FOREST CITY

Commercial Truck Center

Address: 710 WARREN AVE. zone: I-H
Owner: ROGER BLOUIN ADDRESS II: _____
Applicant: FOREST CITY INC.

(B) ~~max~~ WALL SIGN NON ILLUMINATED

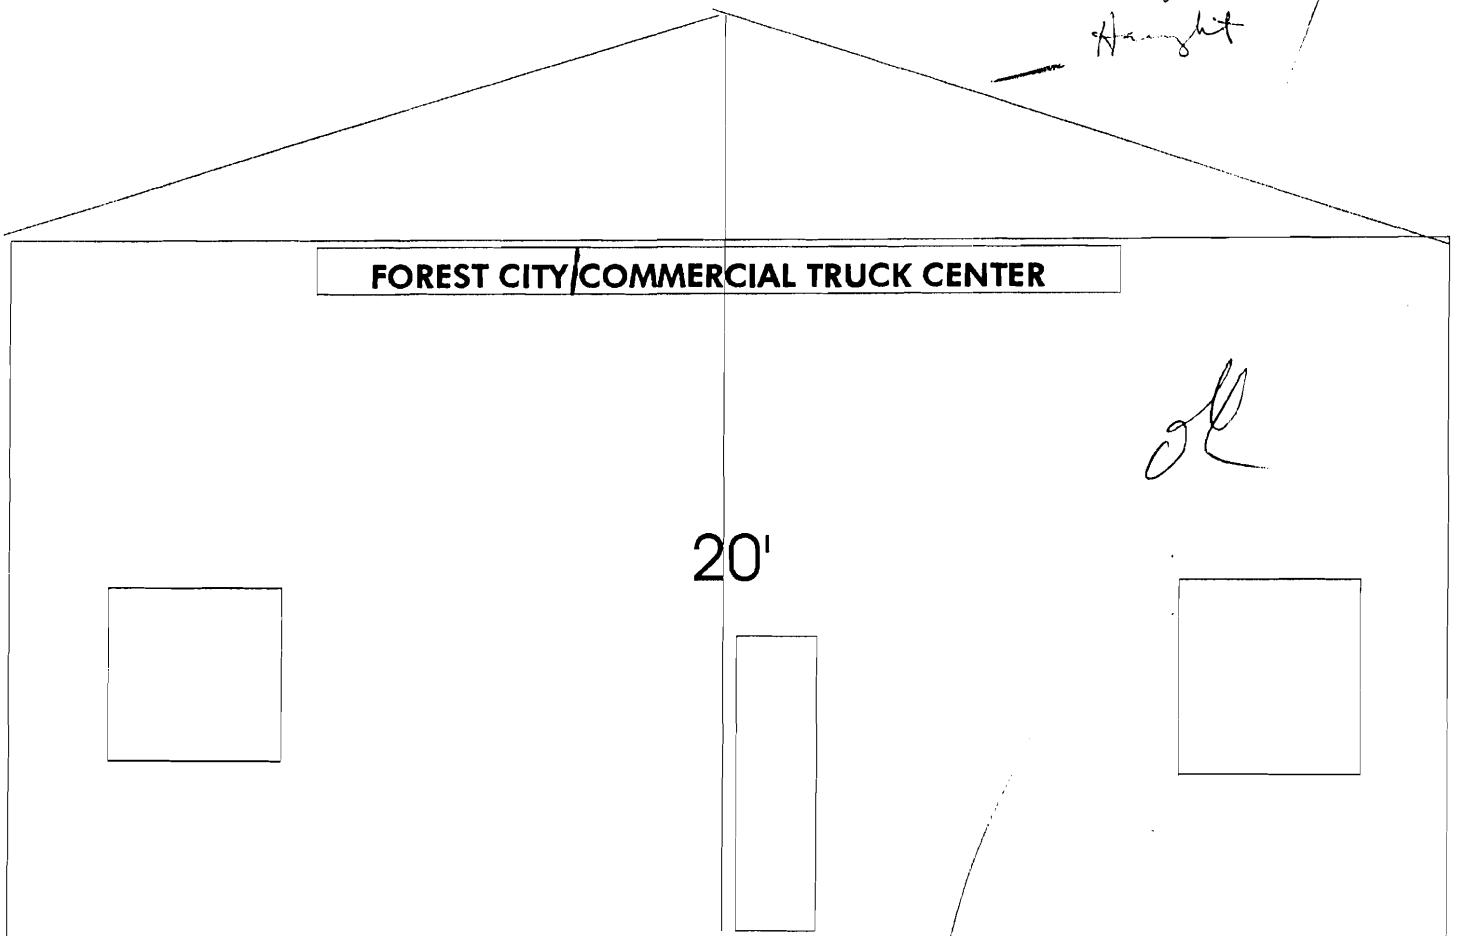
51 x 18 = 918 x 8% = 73.44 ϕ
allowed

*I'm considering
2 principal
FACADES along Riverside
Warren SIGNAGE*

*multi-tenant Bldg
Principal Facade 8'6"
All Other FACADES 2'6"
Shown*
